APPENDIX E
Provincial Peer Review Comment Record

Provincial Peer Review Comments: Centre Wellington Tier Three Water Budget, Physical Characterization Report

APPENDIX F
Local Knowledge Peer Review Comment Record

APPENDIX G
Community Liaison Group Comment Record

Figure 3. DDH-05 profiles of hydraulic head (data from the Ontario Geological Survey)

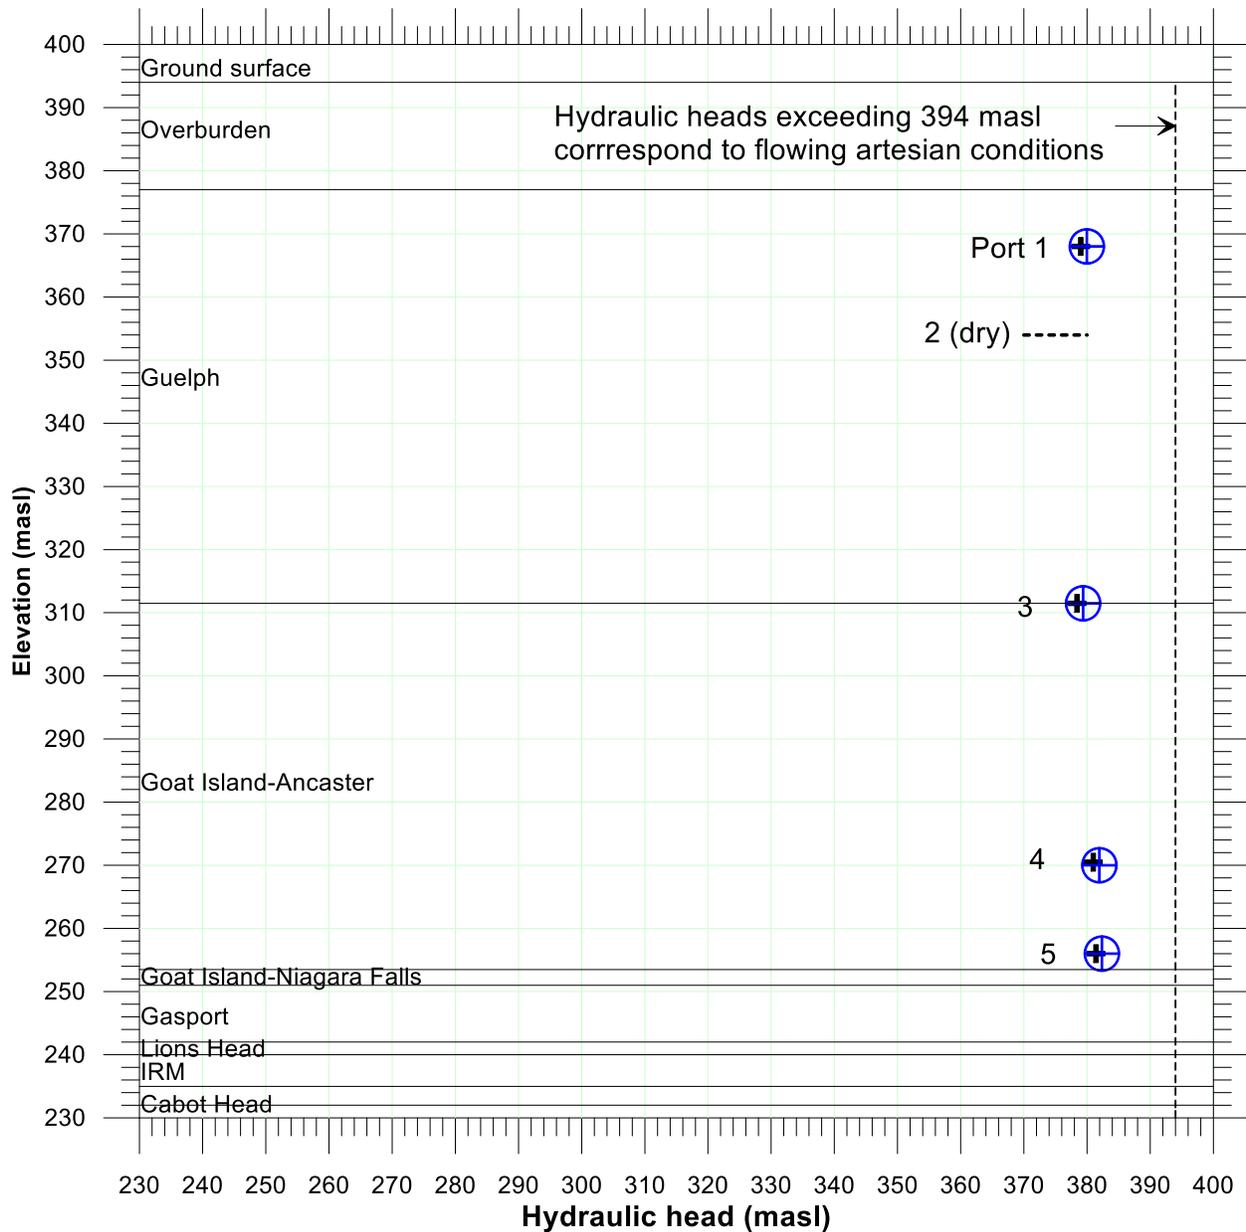
1. The data from a high-quality Ontario Geological Survey (OGS) multilevel well close to the Middlebrook well do not appear to have been included in the analyses.

The OGS borehole DDH5-09 is not indicated in the figure that shows the high-quality wells that have been considered in the calibration. Elizabeth Priebe has indicated to us that the data from two rounds of water level measurements have been provided to the study team. In Figure 3, profiles of hydraulic head from the two rounds are superimposed on the stratigraphic interpretation of Brunton and Brintnell (reproduced in Priebe and Lee, 2016). Continuous water level data have also been collected but are not yet available (E. Priebe, personal communication August 1, 2018).

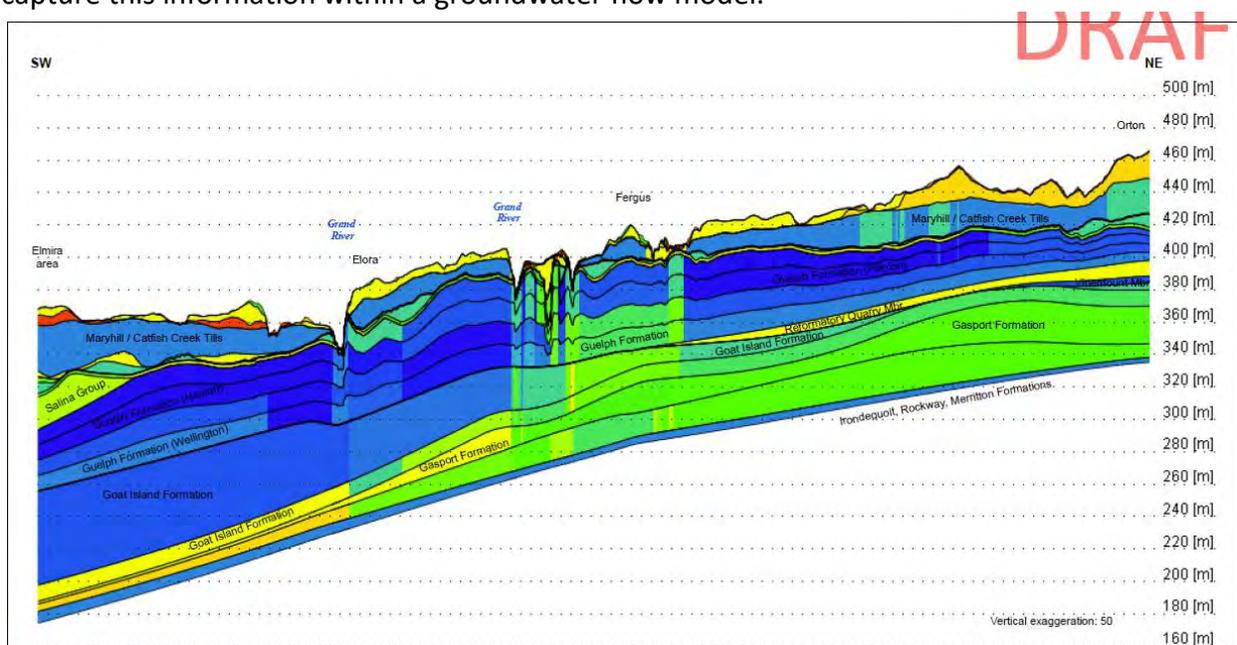
The flow profile and photos from the downhole video collected in the Middlebrook well show that the flow to the long open-interval well is limited to a zone at the lowermost 2 m of the well (Lotowater 2015b). Lotowater describe this zone as a “cavern”. This zone is interpreted to provide over 95% of the water that enters the well. Based on cross-section through the model, reproduced here from Figure 15 of the report, we place the water-producing zone of the Middlebrook well at the bottom of the Goat Island Formation. How is the well simulated in the model? Is the well effectively open across only model layer 19, consistent with the results from the flowmeter profiling or is the well simulated to be open across its entire length, and the model correctly simulates that the flow is concentrated at its bottom?

Frank Brunton (OGS) interprets the lowermost production zone in the Middlebrook Well, and the fracture zones noted in the municipal pumping wells as evidence of karst in the Study Area. The borehole log of DDH-05 presented in Brintnell (2012) includes references to fracture zones within the well as “karst” or “rubble zones.” These areas with enhanced fractures exist at many boreholes within the Study Area; however, mapping the three-dimensional continuity of these zones of enhanced transmissivity is difficult due to the irregular nature of bedrock fractures and the limited extent of high quality data outside the Fergus and Elora areas. As it is difficult to map in three dimensions the locations and spatial distributions of these zones, it is difficult to capture this information within a groundwater flow model.

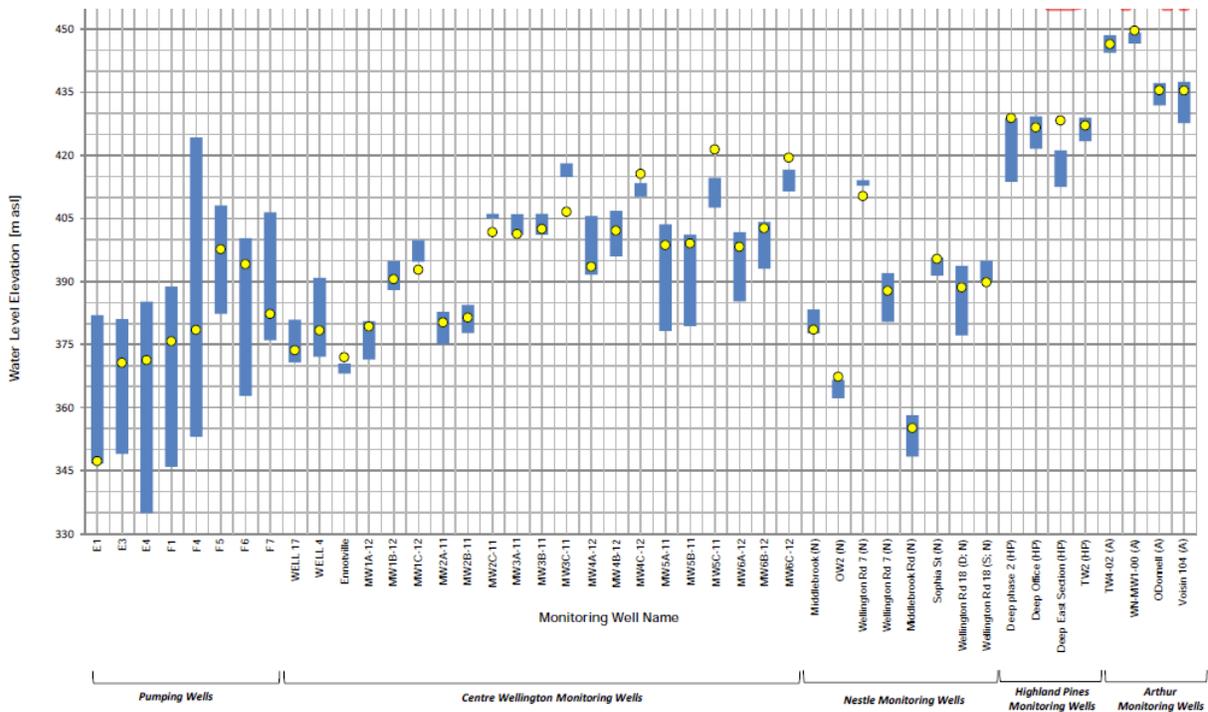
Figure 10 of the draft modeling report shows the match to the “higher quality wells”, with the Middlebrook well included among the 8 Nestlé Monitoring Wells. The reported simulated water level for the Middlebrook well is about 378.5 m asl, with the observations reported to range from about 378 m asl to 383 m asl. It is not clear what these levels represent.

Figure 3. Conceptual model for shallow and deep bedrock levels at the Middlebrook well

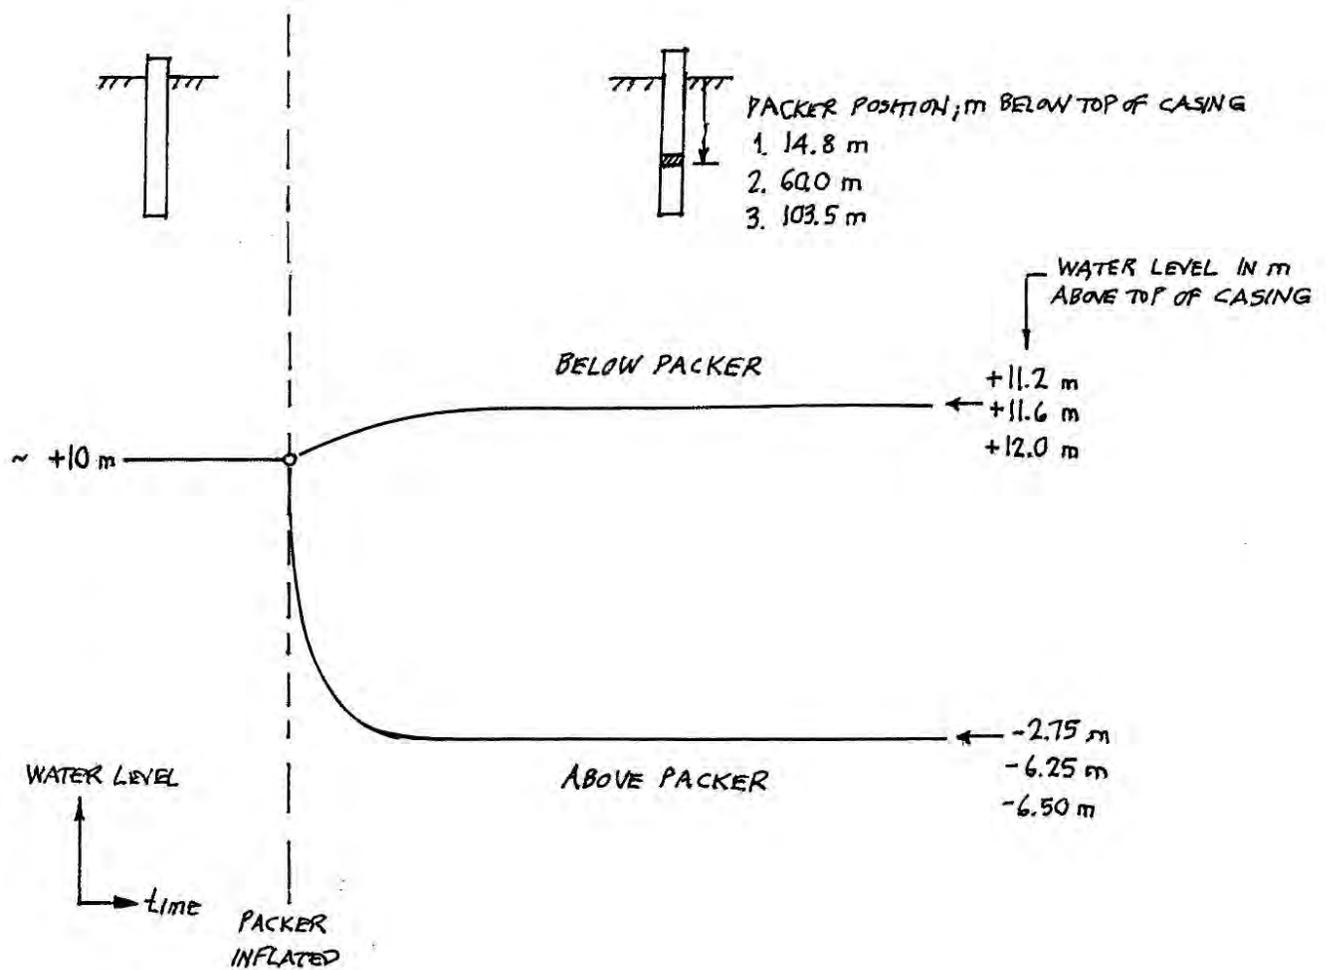
Referring to Gartner Lee (2005), the shut-in (i.e., non-pumping) water level in the Middlebrook well is about 15 m above ground surface (the well logs at the time of completion of the well report 47 ft above ground surface, and 20.5 psi [47.3 ft]). For a ground surface elevation of 365 masl, this corresponds to a hydraulic head of about 380 masl. This represents the composite water level for the long open interval of the well. The packer testing conducted by Lotowater (2015) showed that when the water-producing zone at the bottom of the well is isolated, there is a head differential of about 14 and 17 m between the water-producing zone and the shallow bedrock. Our interpretation of the separation between water levels when the flow zone at the bottom of the well is isolated, or the averaging of water levels when it is not, is illustrated here in Figure 3. Has any attempt been made to match the data and the well discharge rate observed under flowing conditions?

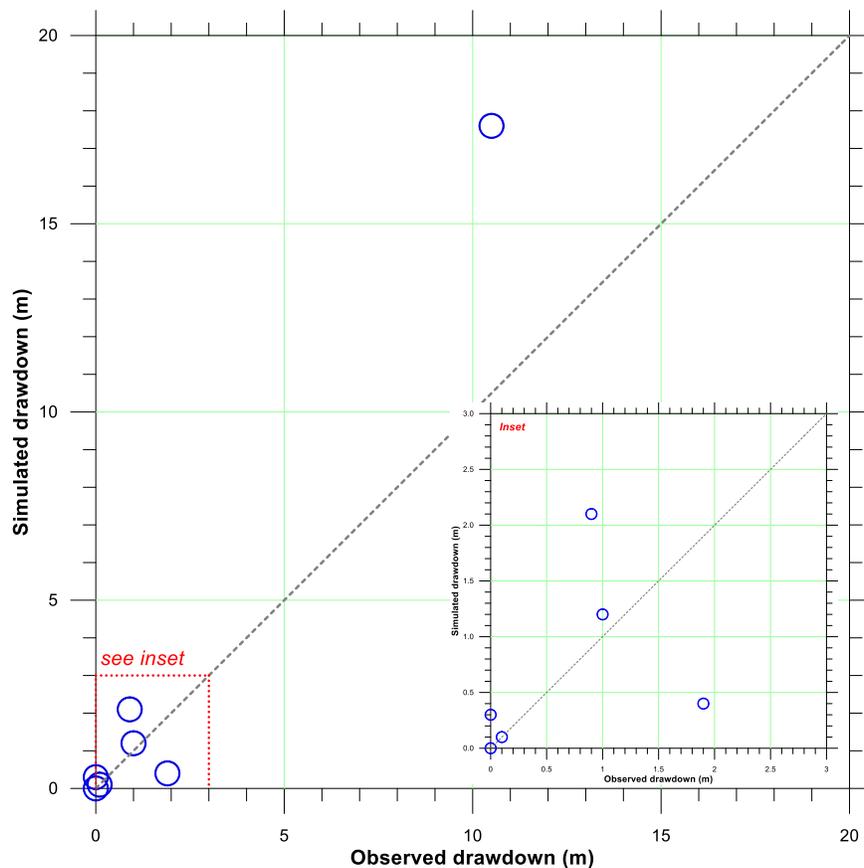
On Table 5 of the report (page 33). Matrix Solutions refer to “Simulated and Observed Drawdown during the 30-day Middlebrook Pumping Test”. What does “during” mean? Are these the simulated drawdowns at the end of 30 days? We are not convinced that they have as good a match as they claim. It is noted in the report that the model does not reproduce conditions around the pumping well. This is important, as the drawdowns in the well are so much larger than the drawdowns observed at the other observation locations. The observed drawdown (and it is really a stabilized drawdown) is 10.5 m, while the simulated drawdown of 17.6 m is much larger. It is indicated in the report that conditions around the Middlebrook well are a “local feature” and that the equivalent porous medium approach used in the study was able to represent the hydraulic responses in the larger groundwater flow system. We are not convinced. The matches to the observed drawdowns at W2 and W4 are not very close either. Our understanding is that one of the objectives of the Tier 3 model was to represent conditions at the Middlebrook well reliably; in our opinion this objective has not yet been accomplished.
